## Bulletin | Danfoss Turbocor Compressors

# Customer Notification

B-CN-442-EN Rev A

**SUBJECT: TT/TG Series Compressor Software Configurations Update**

**Figure 1 - Type Code**

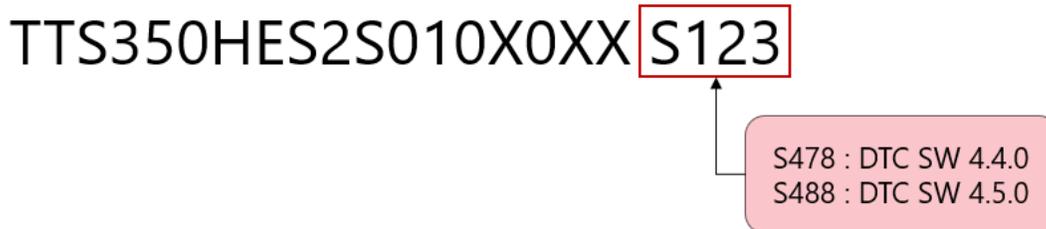
The compressor Type Code defines the software option via the last four characters as shown in the following example:
